# SERVICE BULLETIN

Classification:	Reference:	Date:
EM06-004b	NTB06-072b	September 3, 2009

## DRIVE BELT NOISE

This bulletin has been amended. The Service Procedure, Applied Vehicles / VIN / Date, ACTION, and Claims Information have been revised. Please discard all previous copies of this bulletin.

Figure 1

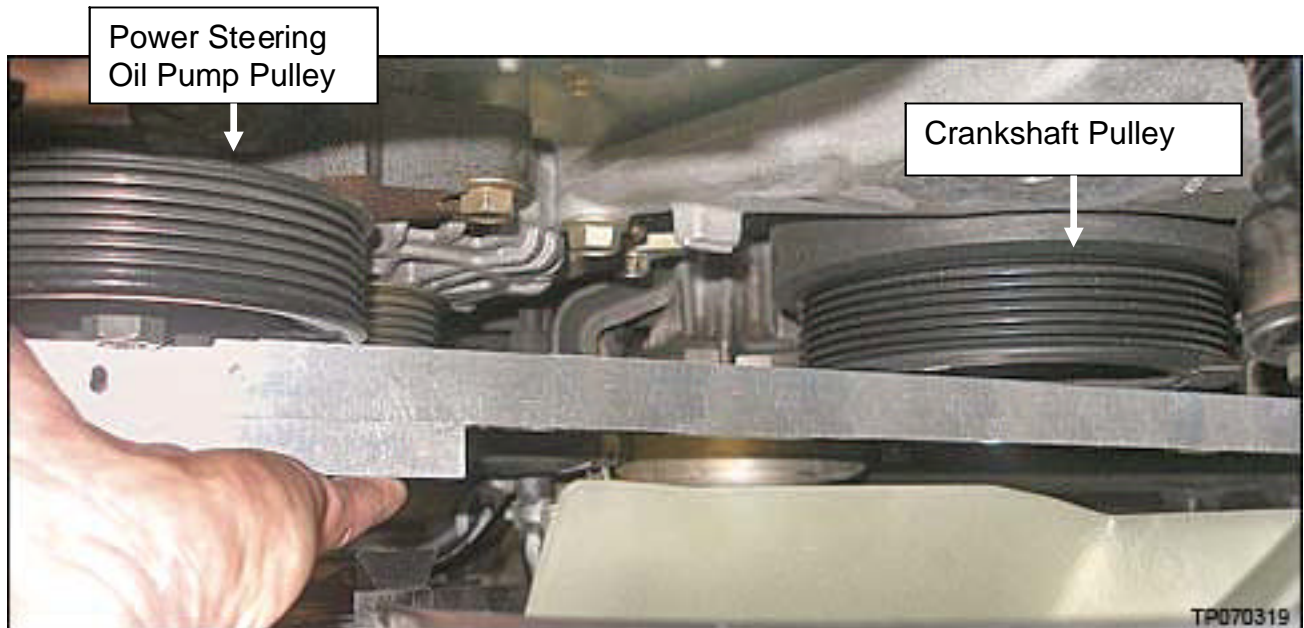
5. Using a straightedge (or other equivalent tool), visually check the power steering oil pump pulley and crankshaft pulley alignment. The pulleys should be evenly aligned as shown in Figure 1.

- If the pulleys are not evenly aligned, go to Step 6.
- If the pulleys are evenly aligned, go to Step 12.

Figure 2

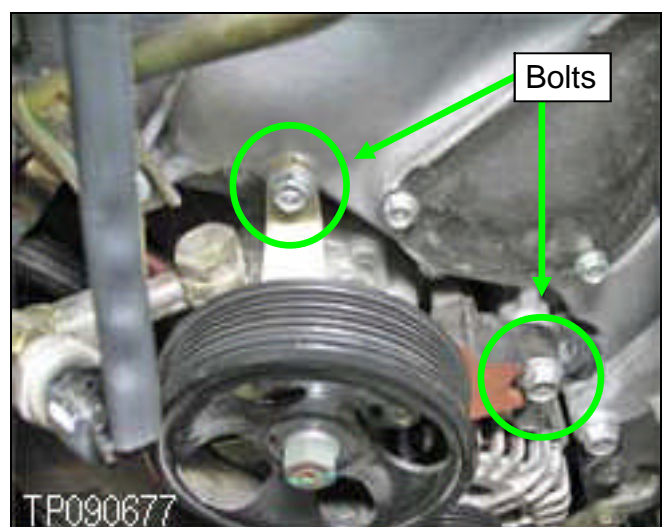
7. Loosen the two front bolts securing the power steering pump bracket to the engine block. See Figure 2.

Figure 3

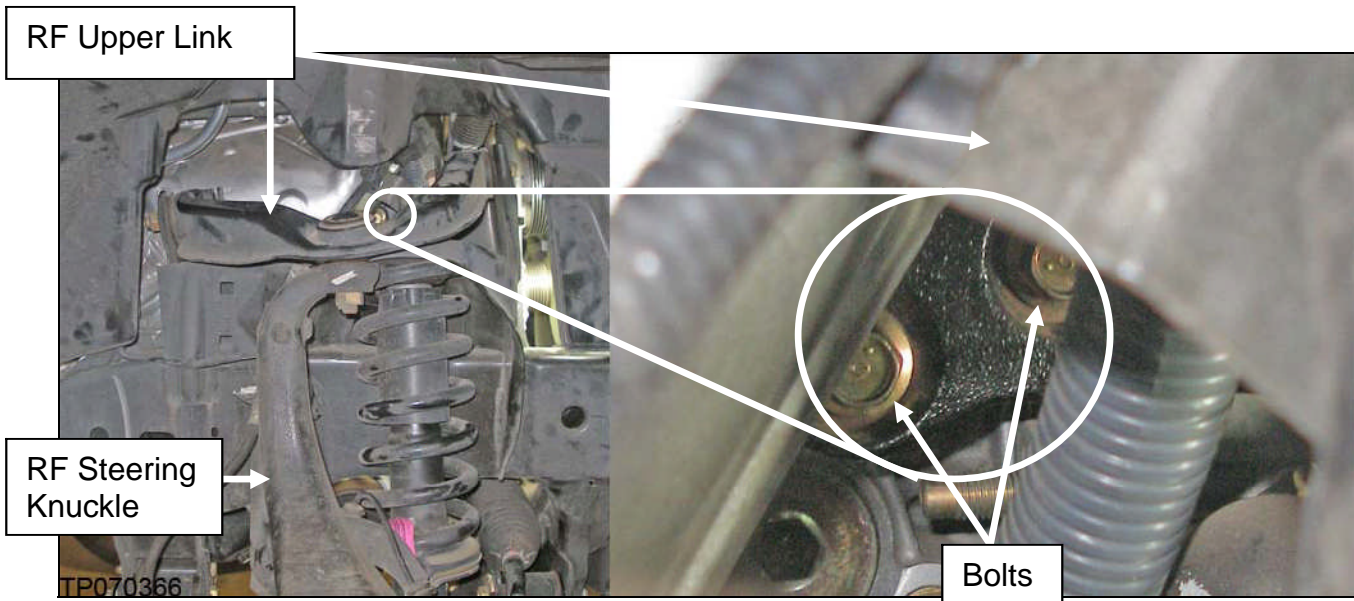
8. Loosen the 2 side bolts on the bracket.

- Torque the lower front bolt 56.9 – 65.7 N•m (5.8 – 6.7 kg-m, **42 – 48 ft-lb**).
- Torque the two side bolts 56.9 – 65.7 N•m (5.8 – 6.7 kg-m, **42 – 48 ft-lb**).
- Torque the upper front bolt to 24.5 – 31.4N•m (2.5 – 3.2kg-m, **18 – 23 ft-lb**).

Figure 4

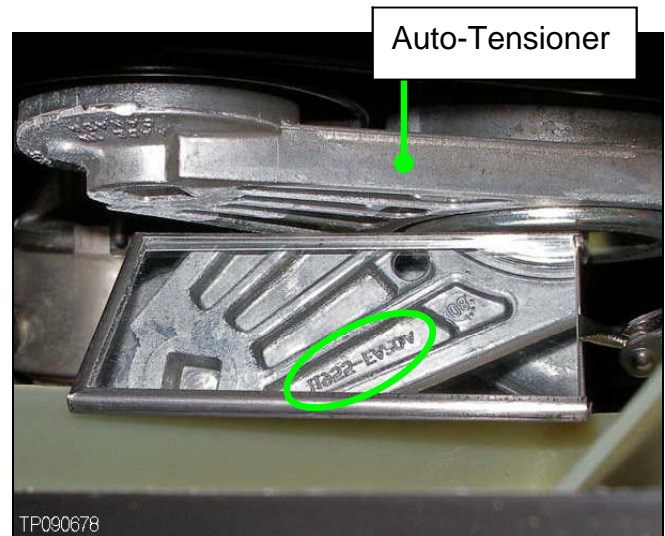
12. Check the part number on the front of the tensioner arm using a mirror (see Figure 4).

- If the part number reads 11955-EA20A, **DO NOT** install a new auto-tensioner.
- If the part number reads 11955-EA200, install a new auto-tensioner.
